NORTH CENTRAL COAST DISTRICT DEPUTY DIRECTOR'S REPORT

TO: Commissioners and Interested Parties
FROM: Dan Carl, North Central Coast District Deputy Director
SUBJECT: *Deputy Director's Report*

NOTICE OF PROPOSED PERMIT AMENDMENT

From: Bart <wavetool@earthlink.net>
Sent: Thursday, September 13, 2012 8:54 AM
To: Lester, Charles@Coastal
Cc: Cavaliere, Madeline@Coastal; Johnsson, Mark@Coastal; Ewing, Lesley@Coastal; Geisler, Karen@Coastal
Subject: Aimco (CDP)2-08-020 Amendment (Objection)

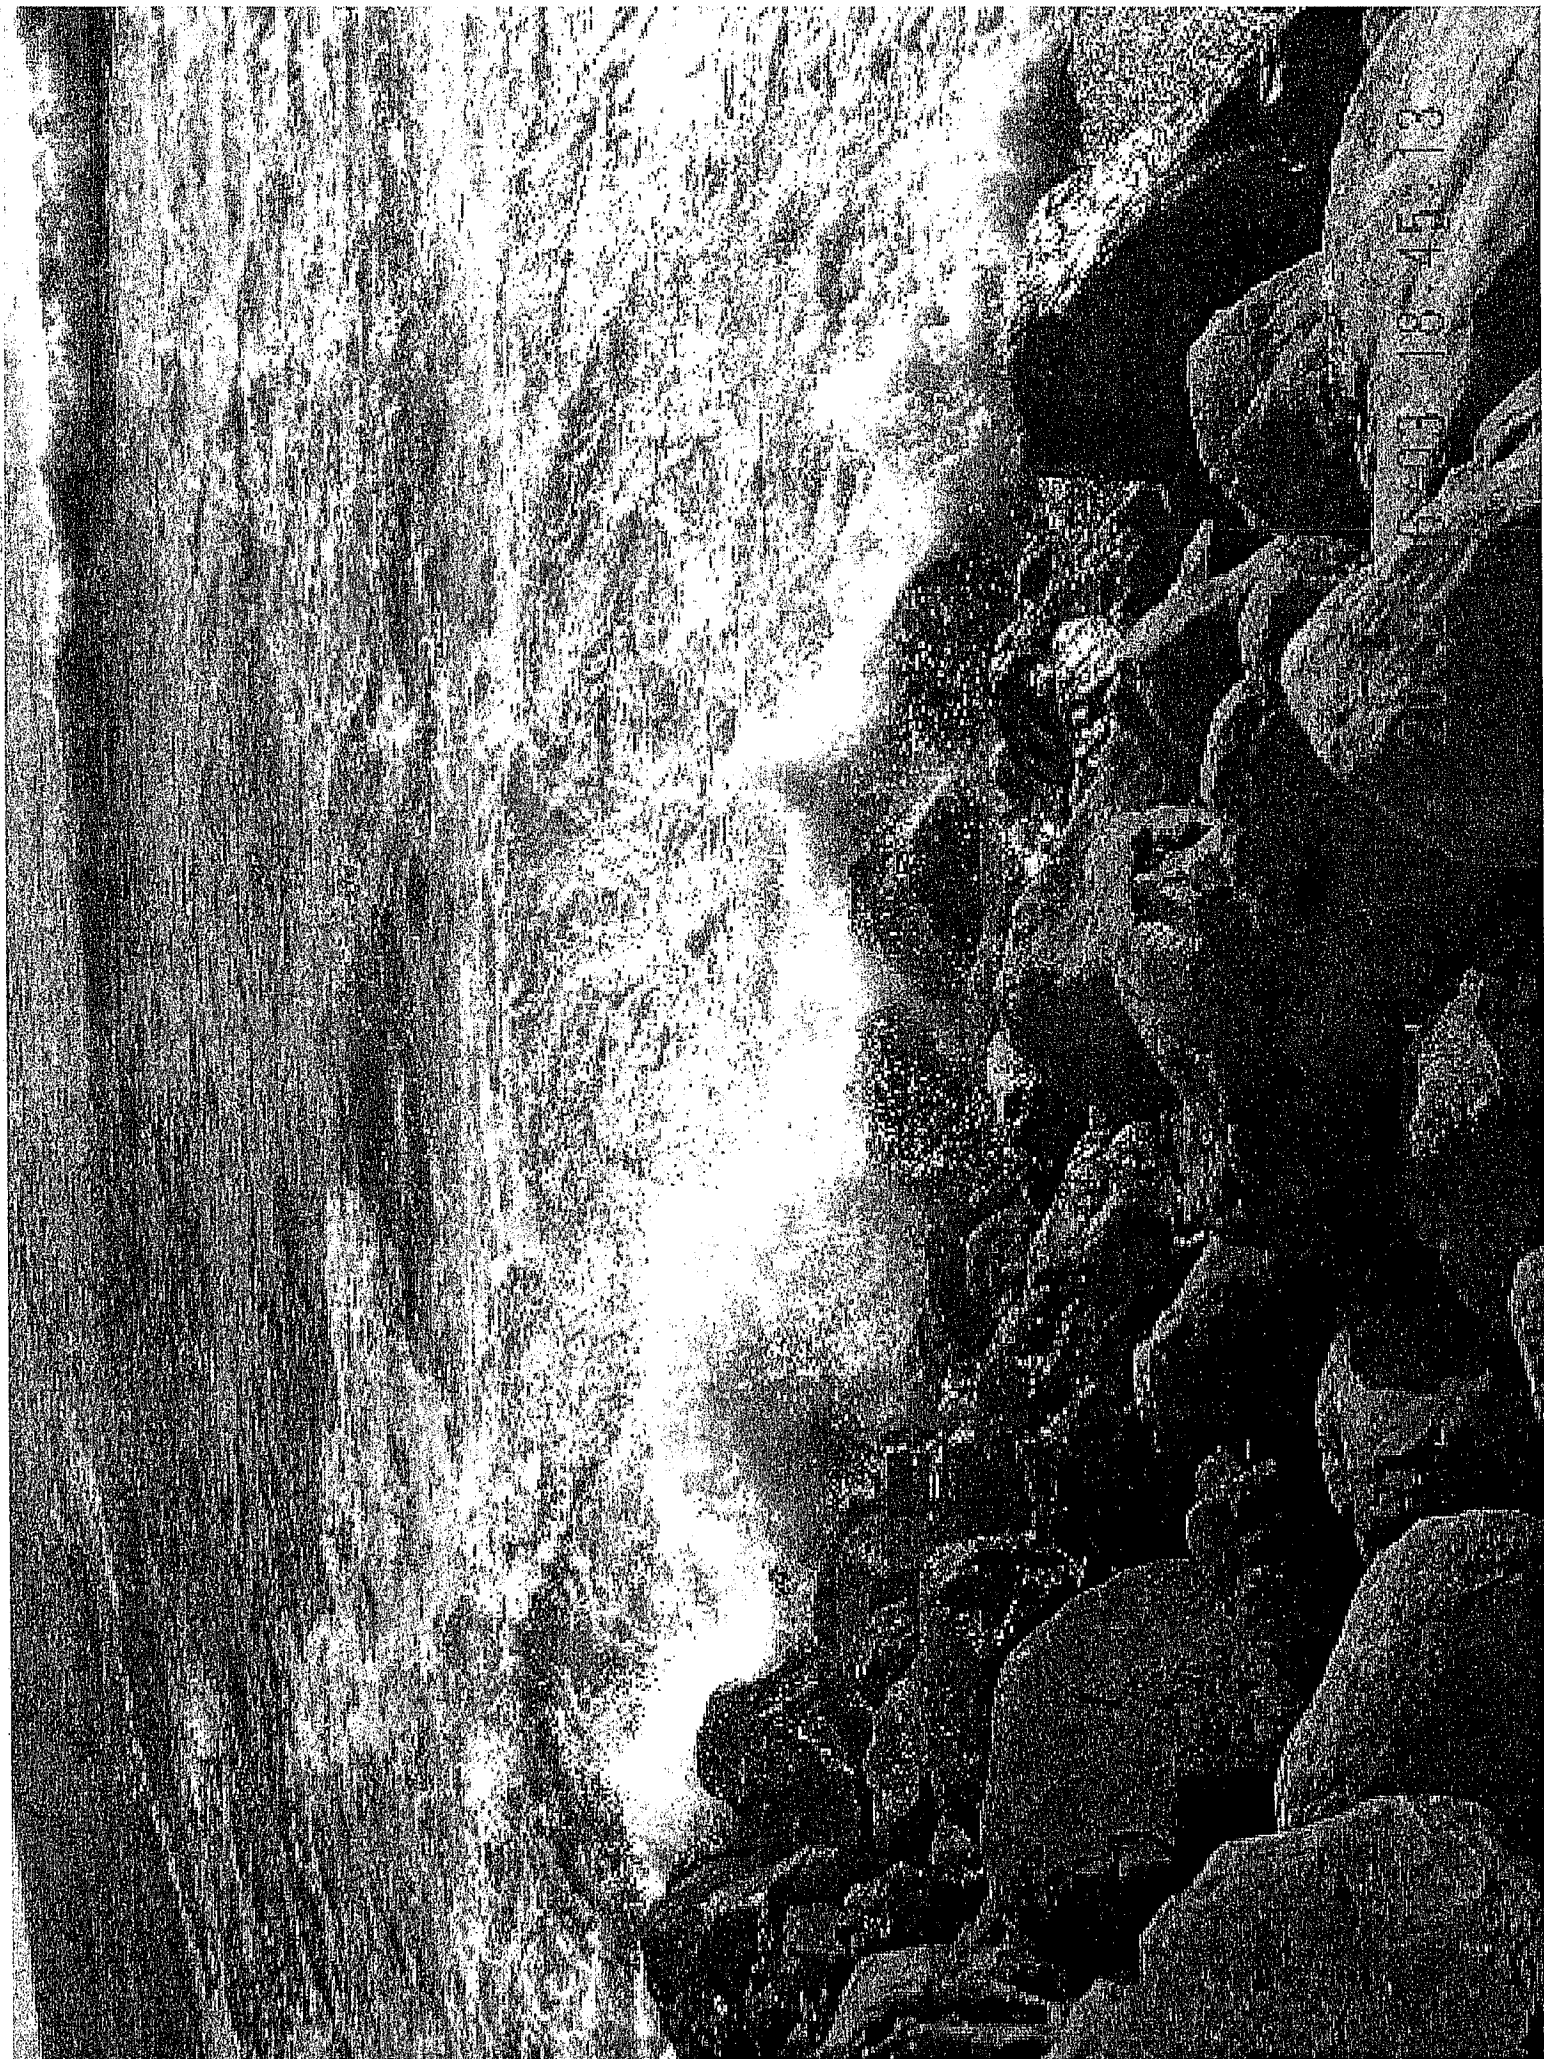
Attached, are various photos (over time) of the revetment located at 380 Esplanade that amply demonstrates that Aimco dedicated "public access" that simply is not viable and not useable by any member of the public in accessing Esplanade Beach North of the Aimco revetment. None of the documentation supplied to me by Aimco, supports where the Mean High Tide is located, does not show where Aimco property ends and state property begins and simply does not show where the "alleged" public has access around the proposed re-stacked revetment in **AREA 7a** and **7b** that supports the toe of the proposed soil nail wall in **AREA 6** (Drawing S-5).

The wave up-rush calculations for this area are not accurate and does not represent the actual up-rush of wave energy during peak periods of scouring. There is a Peninsula Effect that happens at this location because of the land mass that exist at this location and has for several years and mores so since the construction of the revetment in the 1990's.

SECTION B-B'

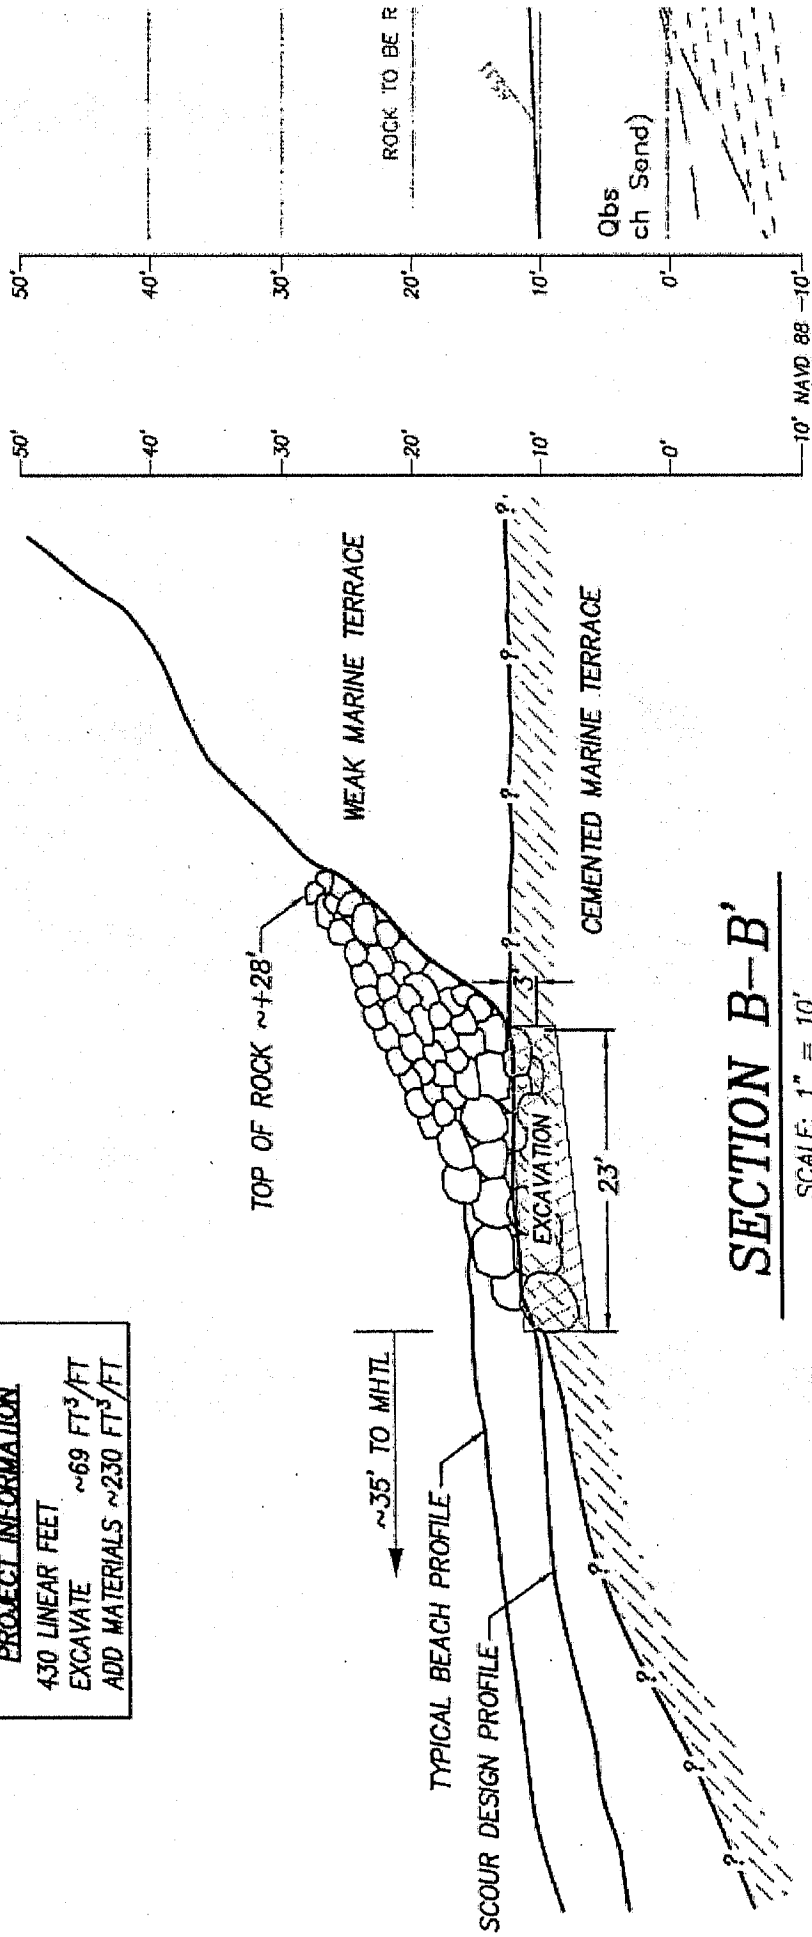
However, I do have some initial observations on the "scour profile" drawing sent. The indication is 35' to Mean High Tide from the outer edge of the revetment? Is that realistic or just an assumption/estimate? Also, I cannot tell from the drawing where state lands property begins and Aimco property ends. Also, given the change in engineered vegetated slope to soil nail wall where is the public easement exactly as it is not drawn on any document that Aimco has presented. Most easements have a legal description and drawing to show where the easement exist on the property.

2. 2. Scour and Design Profile: In the TRC report, the greenstone was the basis for the winter scour profile. This is a reasonable a prudent assumption. Page 4, they assumed greenstone at Elevation +2 to +4 and the toe to be constructed 4 feet into the rock. However, the Geosoils plans and depictions present the cemented marine terrace. No information and clarification as to the erodibility of this material is presented or susceptibility to long-term wear/softening is provided. Further, a design profile is provided on the Geosoils plans, and it is not clear the basis for this profile. The "weakly cemented sands" pointed out in the TRC report are highly erosive. It is unclear how any prudent design can conclude that the revetment would not be undermined. Additional data must be available to justify this design, that has not been provided to date.

8. 7. Soil Nail and Revetment Overlap: The plans shows an overlap but no specifications as to how much ? Given the discussion in Item 7, this revetment may and will be overtopped. If so, if the rip rap is not constructed properly, and with sufficient point contacts, the stones will be dislodged and/or not dissipate wave energy. This may result in the stones being used as battering rams against the wall. We could not find specific rock size callouts for the upper rock or if cap rock was designed and intended. Further, it is not clear if the 13 inch wall section was intended/ designed to withstand wave impact forces.

9. The plans lack certain specificity for construction. A few examples include but not limited to: a) TRC recommends the rip rap be placed at a 2:1. b) No such callout is presented on the plans. c) No provisions or callout are made for stability fabric or drainage. d) The keyway specification in TRC does not match Geosoils.
